MEMO

Re: Follow-up to the presentation at the November 16, 2022 ITCAC Meeting

Southdale Road West and Colonel Talbot Road Roundabout

Figure 29: Pedestrian Crossover Level 2 Type B – Double-Lane Roundabout

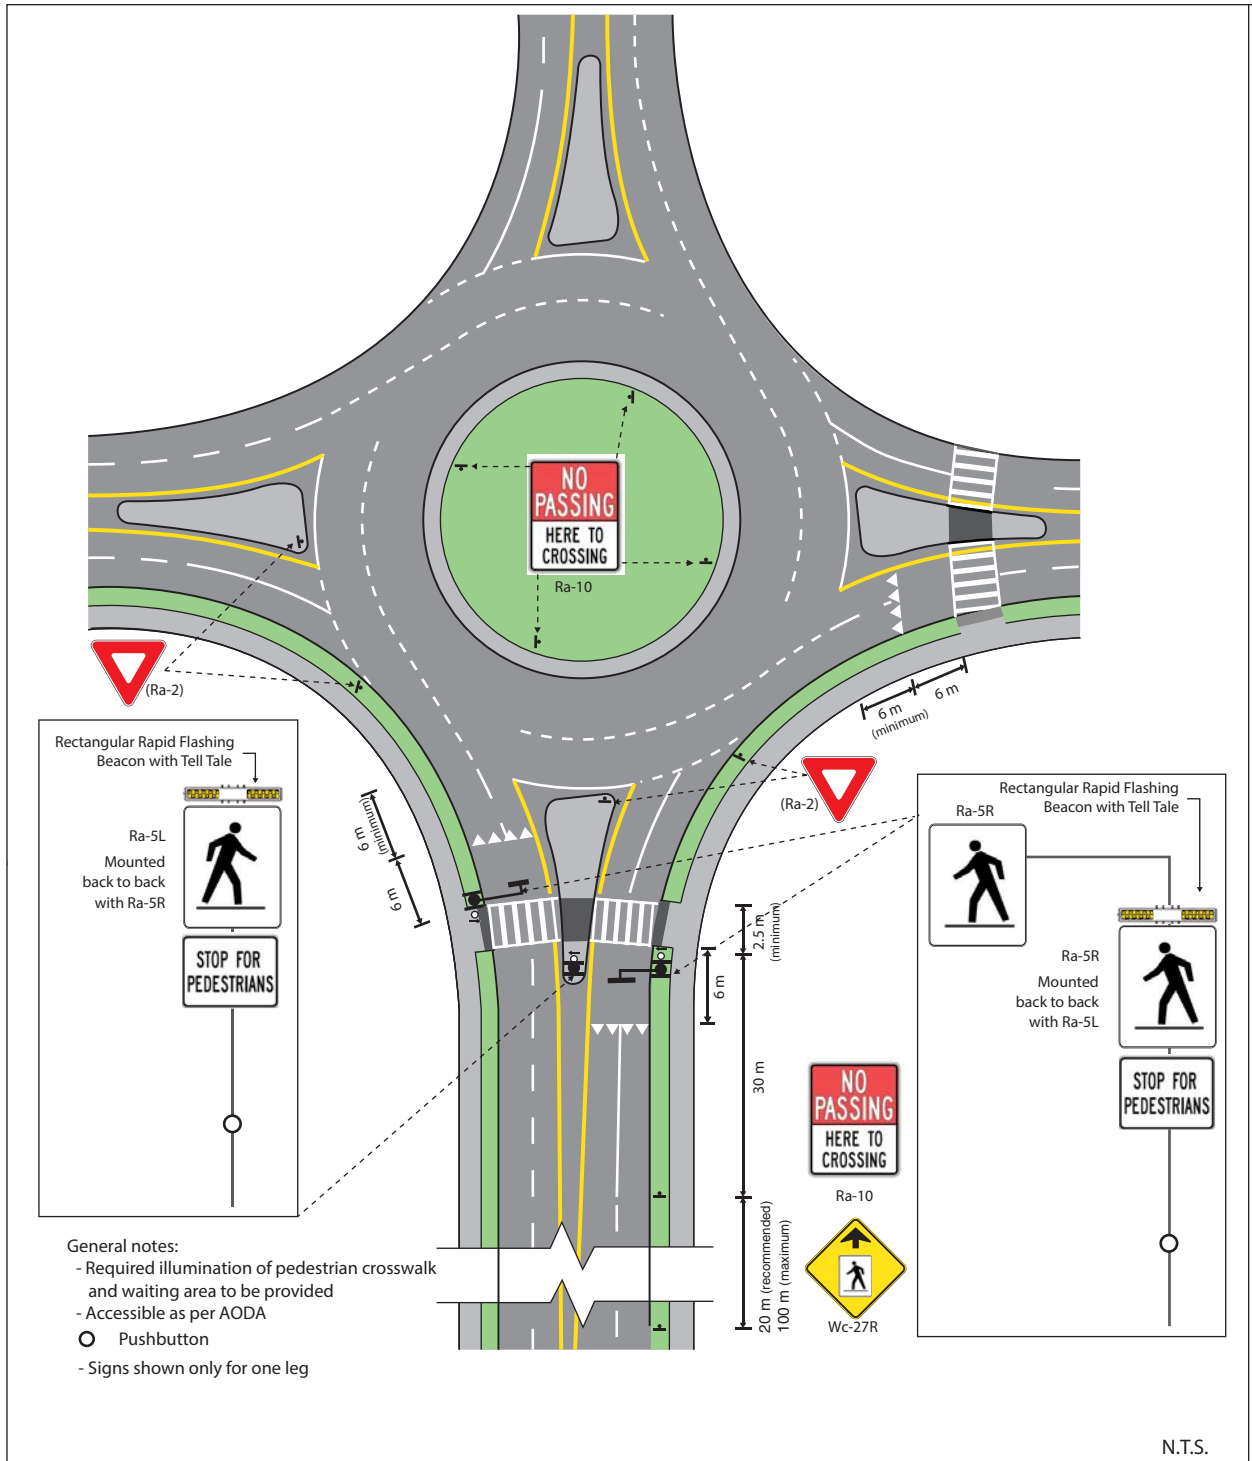
Comment #4: ITCAC identified their concern with respect to pedestrian movements at the two lane roundabout due to the removal of the existing traffic signals. A question was asked about the specific provisions that are incorporated into the design that would assist the public to traverse the intersection.

Response: Since the ITCAC meeting occurred, the design has been revised to include a higher level of pedestrian crossing treatment. The initially proposed pedestrian cross-over (PXO) design (as provided in Ontario Traffic Manual Book 15 Type D PXO) has been upgraded to a design with additional features known as a Type B PXO design. The design of the pedestrian cross-overs include a pedestrian push button, flashing beacons, overhead and ground mounted signage, and pavement markings. The roundabout design includes these enhanced pedestrian crossings on all four legs of the intersection. The

pedestrian crossings will meet the current accessibility requirements to support safe crossing.

The pedestrian cross-over details (known as a Type B PXO) were presented to the public at the online public update meeting and at the in-person drop in session. An excerpt from Ontario Traffic Manual (OTM) Book 15 showing the features of a Type B PXO is included as an attachment to this memo.
